# Staff Report PC21-044-DP

### Docket PC21-044-DP – Development Plan – Culvers Restaurant

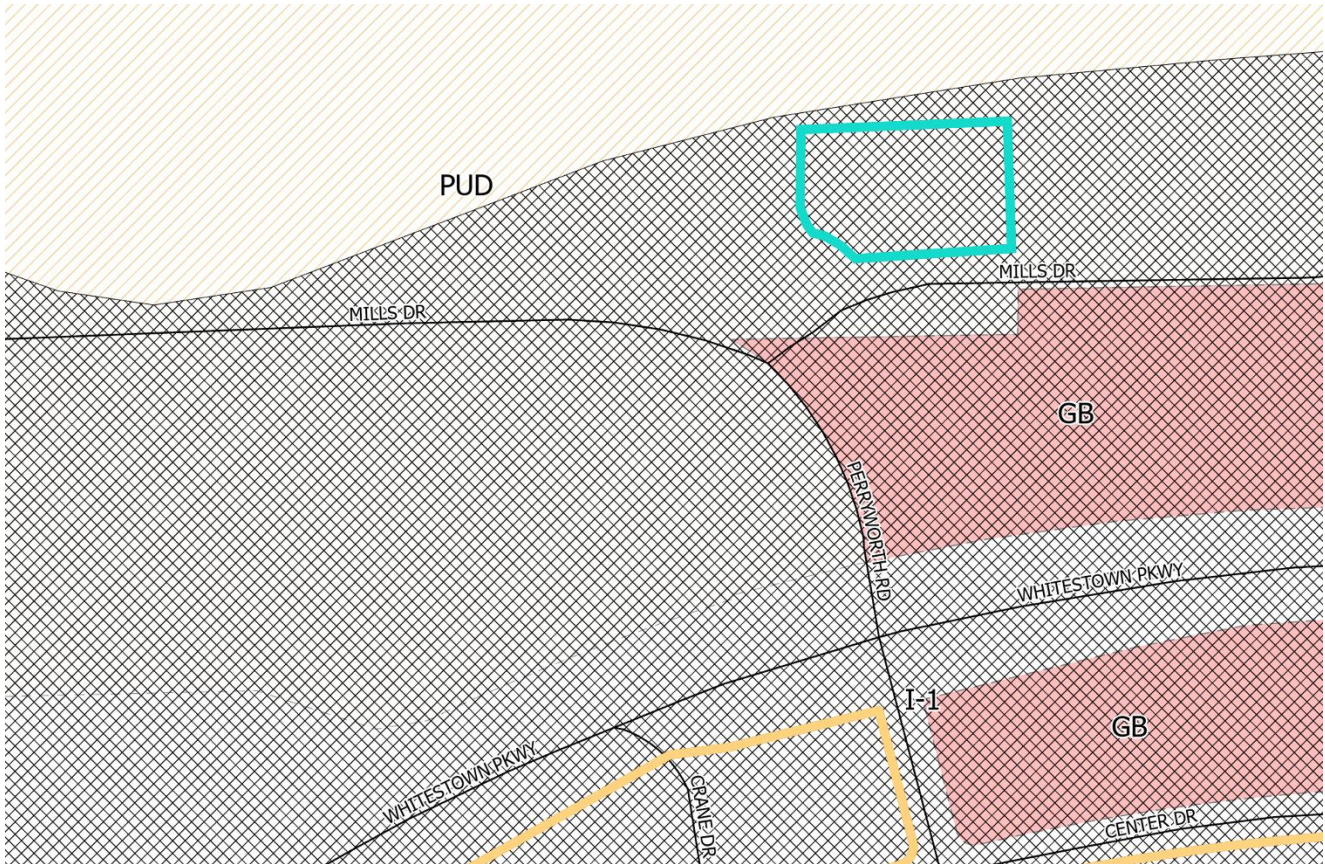
- A drive-thru on the rear and east side of the site;
- Proposed onsite parking including approximately:
  - 57 standard parking stalls;
  - 3 ADA parking stalls; and,
  - 3 bicycle racks.
- Two access points on the north side of the site;
- Proposed pedestrian network along Mills Drive, the west side, and north side of the site;
  - Internal pedestrian network and a connection to the west side sidewalk;
- Proposed dumpster enclosure on site;
- Proposed monument sign on the south side of the site;
- Landscape plan that meets the requirements of the Anson PUD;
- Photometric plan that meets the requirements of the Anson PUD;
- Architectural elevations that meet the requirements of the Anson PUD and corridor overlay;
  - The proposed height is approximately 18' where the minimum height required in the Corridor is 20'.

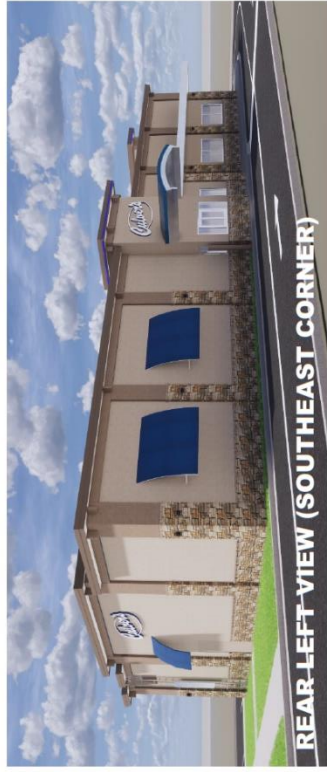
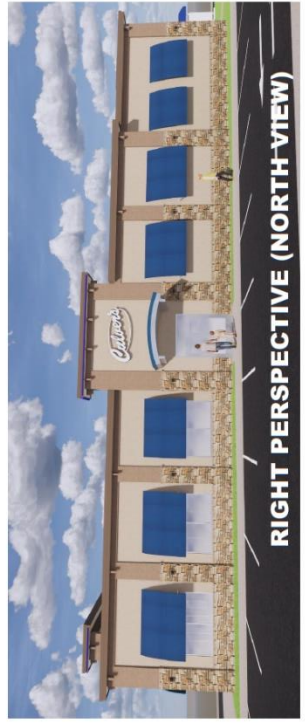
The proposed Development Plan is in compliance with the Anson PUD and the Whitestown UDO, with the exception of the building height.

If Plan Commission approves PC21-044-DP, the approval should be conditioned that the height of the building meets the requirements of the Anson PUD and I-65 Corridor Overlay.
